Service Bulletin No: 24-005

Modification No: EC-18-0038

**ELECTRICAL POWER - DC ELECTRICAL LOAD DISTRIBUTION
INTRODUCTION OF ADDITIONAL ATTACHMENT HARDWARE TO HOLD A CABLE LOOM AT THE LH
COCKPIT RAIL INSTALLATION****1. Planning Information****A. Effectivity**

Installation of Additional Attachment Hardware to the LH Cockpit Rail Assembly Wiring-Loom
Figure 1

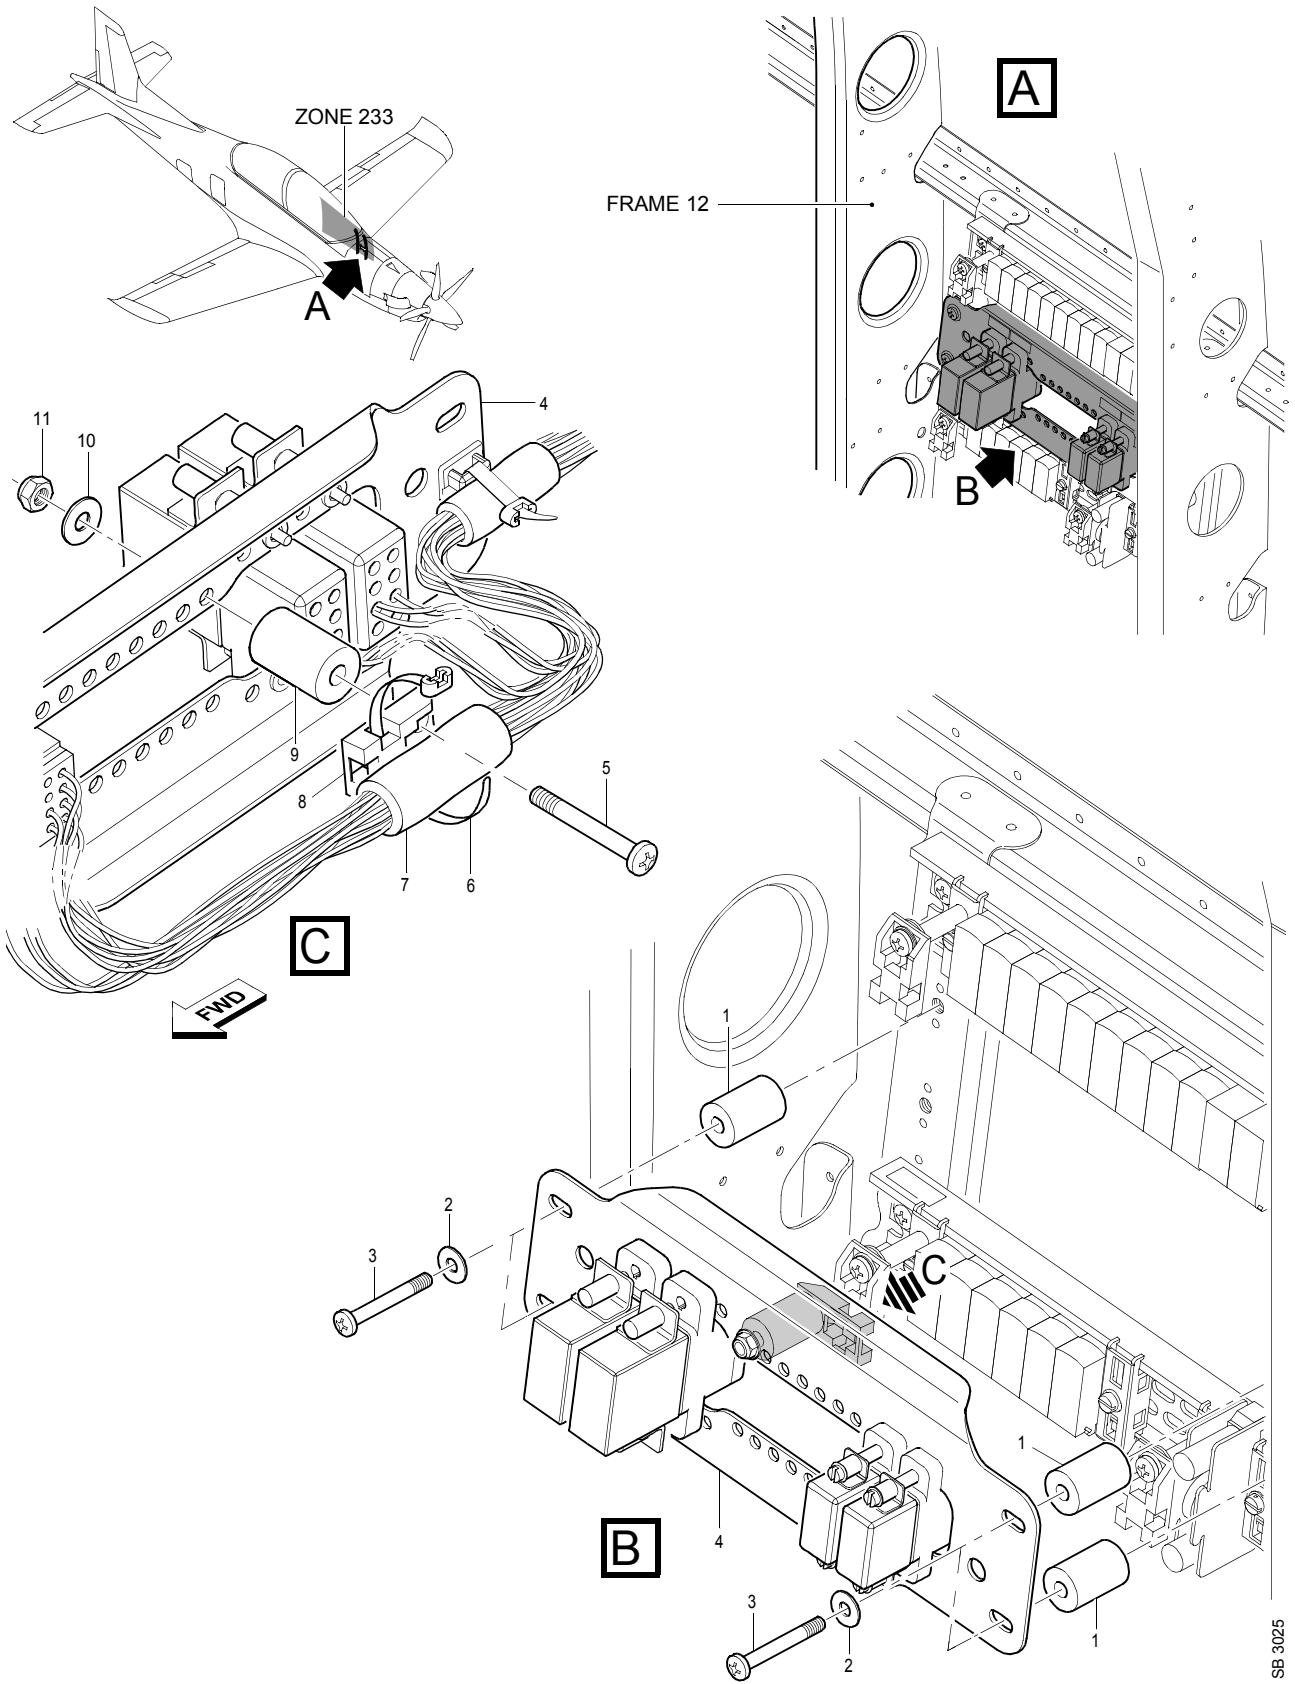
Five wires that are part of a cable loom behind the LH cockpit rail installation were found to be damaged. The damage was caused by the attachment screws of the relays K106 and K107. The relays are installed to the frame support assembly of the LH cockpit rail installation.

The frame support assembly is partially removed and a visual inspection is made of the cable loom for chafing and damage. If necessary, the chafed and damaged wires are repaired. To prevent future chafing and damage to the wires, additional attachment hardware is installed to hold the cable loom away from the attachment screws of the relays K106 and K107.

- (1) Identify the frame support assembly (4) on the LH cockpit rail installation (Ref. Detail A).
- (2) Remove one screw (3) and washer (2) and then carefully remove the distance bush (1) from the frame support assembly (4).

- (4) Carefully pull the frame support assembly (4) sufficiently away from the aircraft structure to get access to the rear of the frame support assembly (4).
- (5) Do a visual inspection of the cable loom behind the frame support assembly (4).
- (6) If you find damage to the cable loom, contact Pilatus for technical support and do the repairs as necessary. When you have done the repairs, or if you do not find damage, continue with this Service Bulletin from Step 3.B.(7).
- (7) Put the new attachment hardware in position on the rear side of the frame support assembly (4) as follows:
 - The screw (5) (Pos. No. 30)
 - The mounting base (8) (Pos. No. 20)
 - The distance bush (9) (Pos. No. 10).
- (8) Loosely install the new washer (10) (Pos. No. 50) and the new nut (11) (Pos. No. 40) on the screw (5) (Pos. No. 30).

- (9) Align the mounting base (8) (Pos. No. 20) longitudinally with the frame support assembly (4) and hold it in position.
- (10) Tighten the nut (11) (Pos. No. 40) on the screw (5) (Pos. No. 30).

- (11) In the area where the cable loom interfaces with the mounting base (8) (Pos. No. 20), apply the red fiberglass tape (7) (Material No. P09-064) to the cable loom (Ref Detail C).

- (12) Install the new cable tie (6) (Material No. P09-005) to the mounting base (8) (Pos. No. 20) and the cable loom.
- (13) Make sure that there is clearance between the cable loom and the attachment screws of the relays K106 and K107.
